# PALMDALE WATER DISTRICT WATER SYSTEM MASTER PLAN

Final Program EIR  
State Clearinghouse No. 2017021042

Prepared for  
Palmdale Water District

November 2018

**Figure 4-1**  
 Cumulative Projects – Page 1

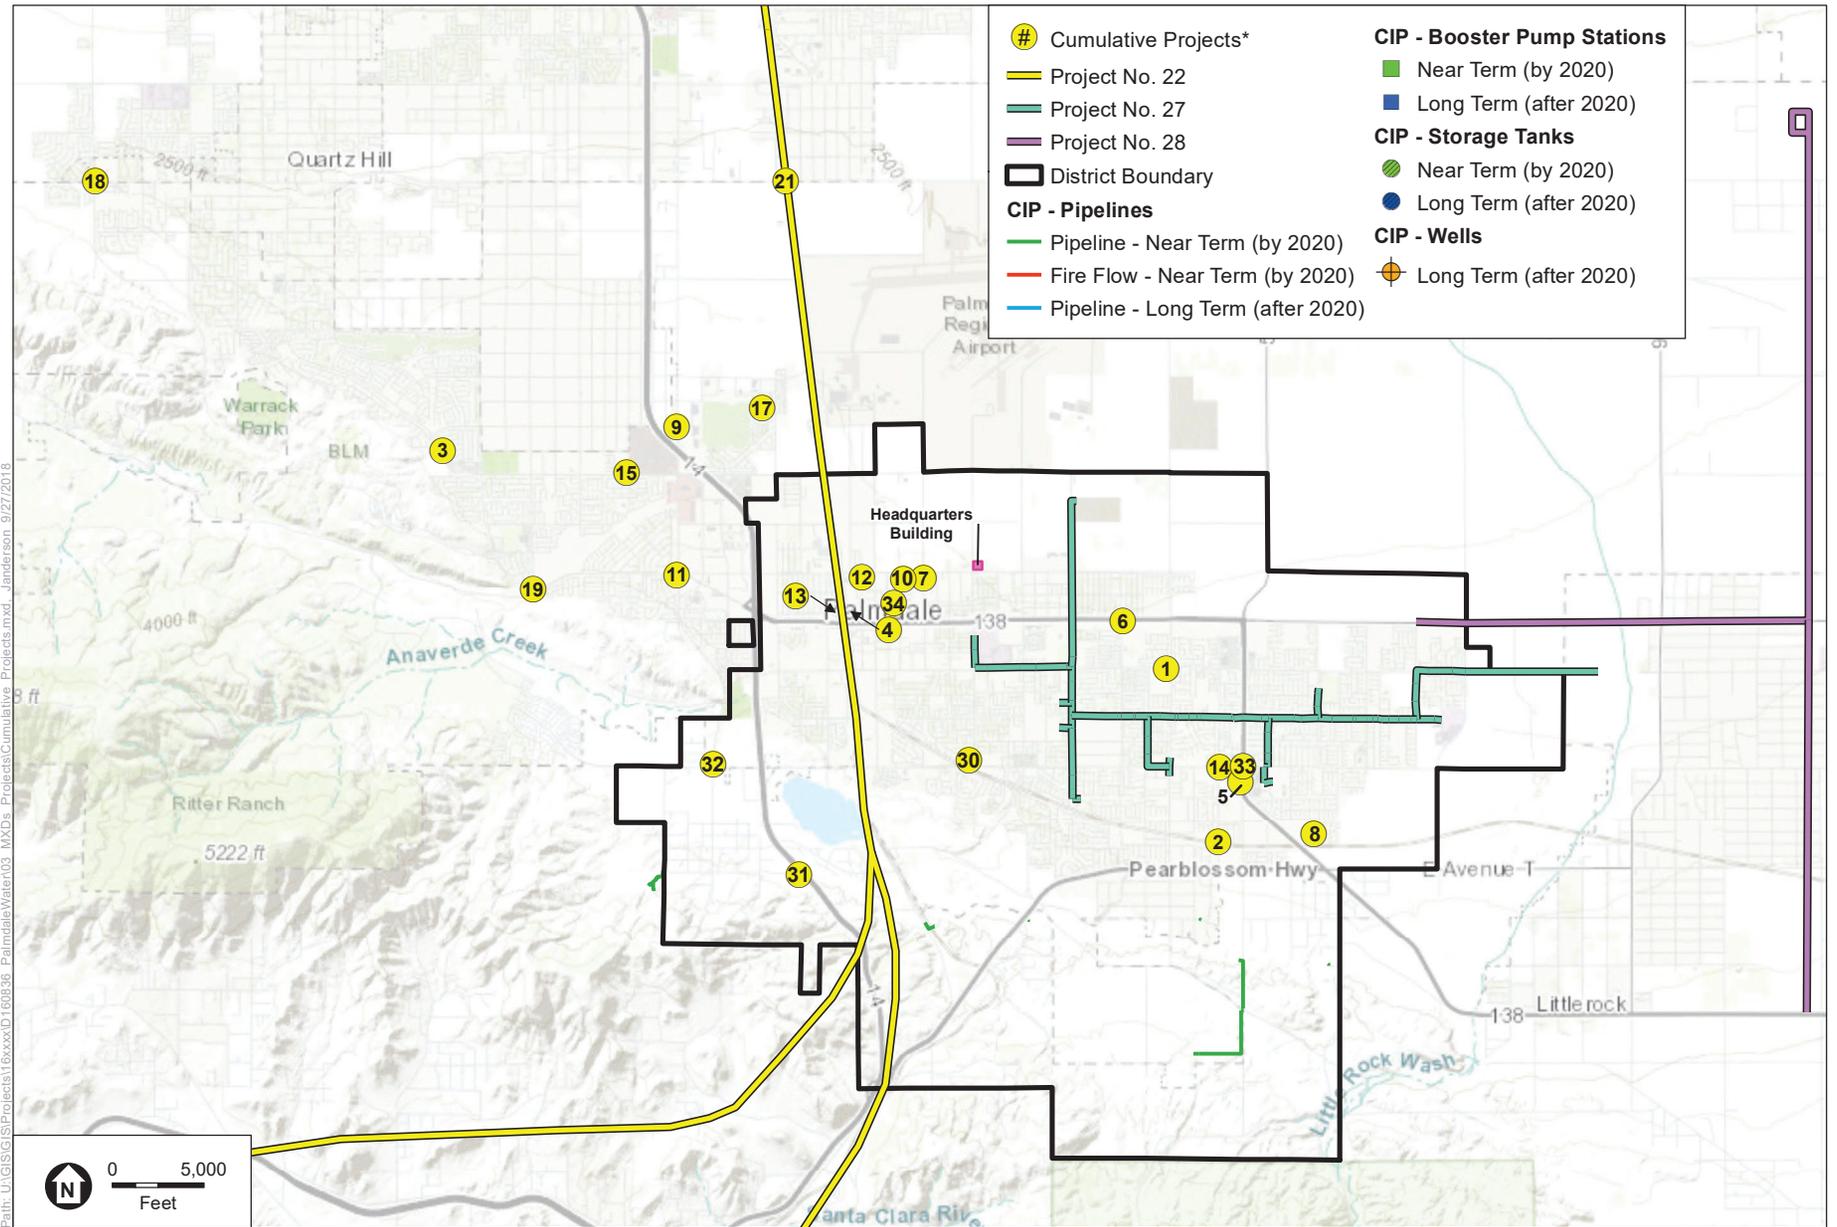
The Draft PEIR text in Table 4-2 on page 4-6 has been updated as follows. Accordingly, the Draft PEIR Figure 4-1 has been revised as to show these cumulative projects:

<u>30</u>	<u>City of Palmdale</u>	<u>Residential and Commercial</u>	<u>North Side of Ave S, east of the alignment with 20th Street West</u>	<u>Commercial and Residential</u>	<u>Royal Investors Group LLC</u>	<u>Residential and Commercial</u>	<u>Applied 5/16/2017</u>
<u>31</u>	<u>City of Palmdale</u>	<u>Residential and Commercial</u>	<u>South of Avenue S; 1.2 miles west of SR-14</u>	<u>Commercial and Residential</u>	<u>Stephan Jenkins</u>	<u>Residential and Commercial</u>	<u>Applied 10/10/2017</u>
<u>32</u>	<u>City of Palmdale</u>	<u>Residential and Commercial</u>	<u>NWC and NEC of Tierra Subida and Avenue S</u>	<u>Commercial and Residential</u>	<u>Caliber Retail Properties Group</u>	<u>Residential and Commercial</u>	<u>Applied 12/19/2017</u>
<u>33</u>	<u>City of Palmdale</u>	<u>Commercial Shopping Center</u>	<u>South of Avenue S on the west side of 47th Street East</u>	<u>Commercial</u>	<u>Intertex Companies</u>	<u>A proposal to construct a commercial shopping center</u>	<u>Applied 4/25/2018</u>
